Determination 2009/86

Determination regarding the refusal to issue a code compliance certificate for house alterations and a new garage at 3 Le Roy Road, Waiheke Island

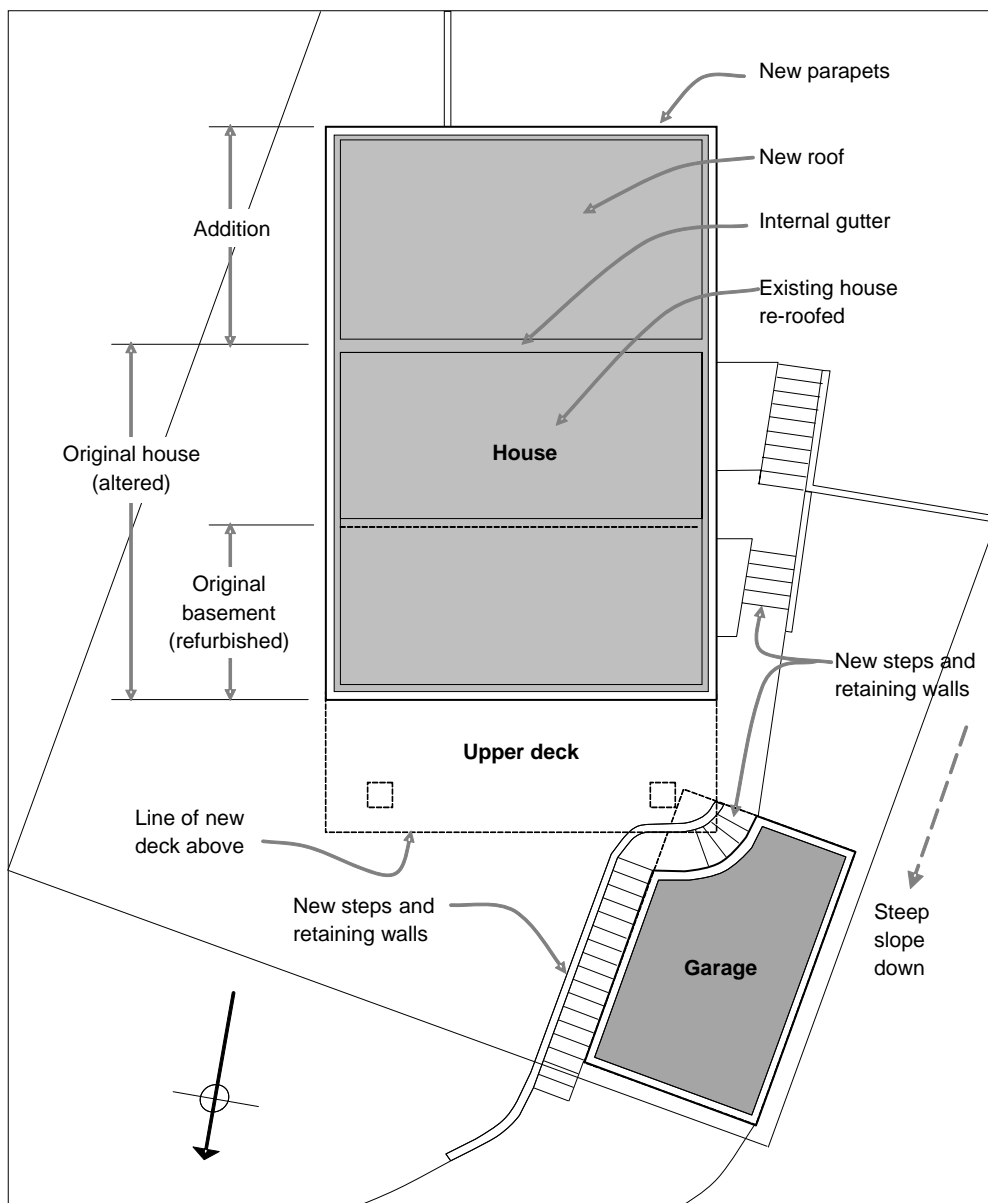
2.3.1 The building work considered in this determination is shown in the following sketch:
